REQUEST FOR INFORMATION DATE: September 20, 2016 NO.: RFI-290

Project Name: 15051-Webster University Interdisciplinary Science Building Project No.: 15051

Subject: Confirm brick ledge dimension

1 WEST ELEVATION

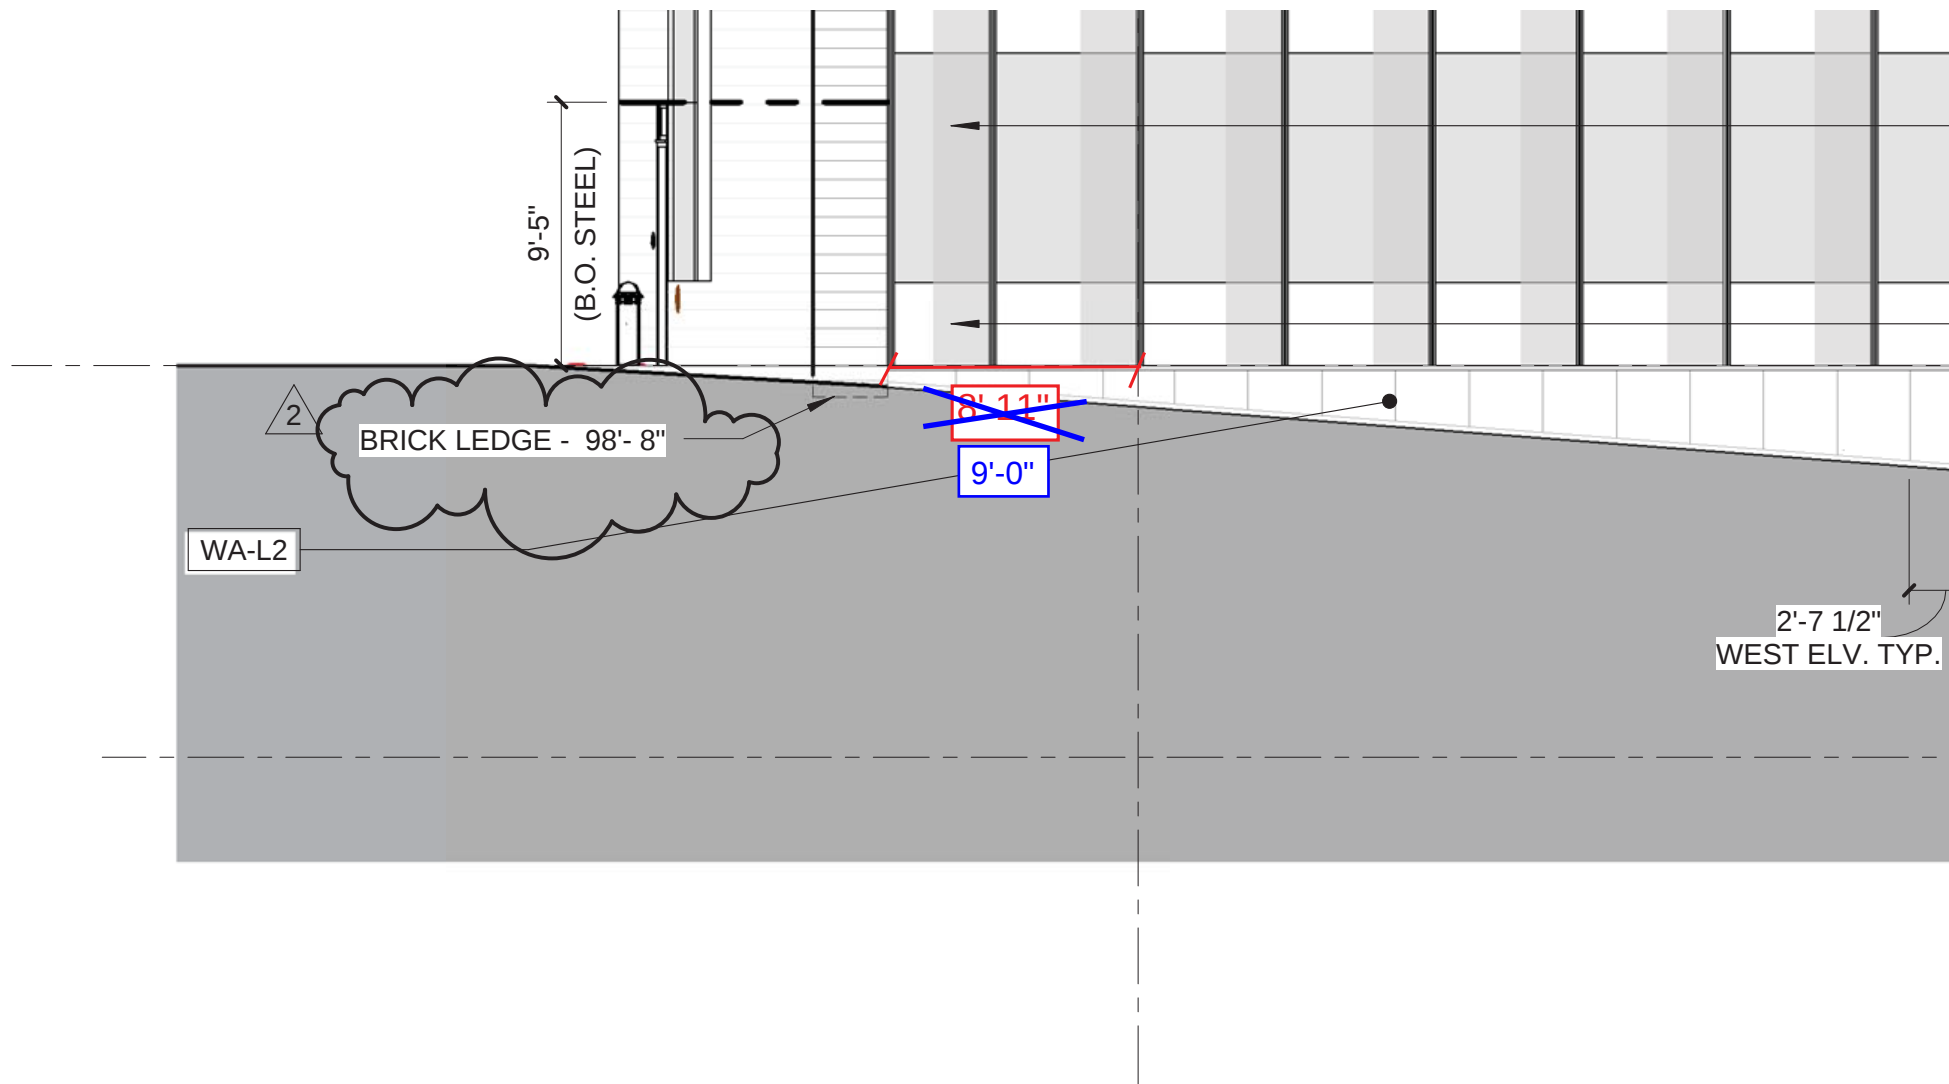
Please confirm the brick ledge shown on the west view of A0311 is to begin 8' 11" west of F line (see attached sketch)

Brick ledge should be 9'-0" west of column line F.
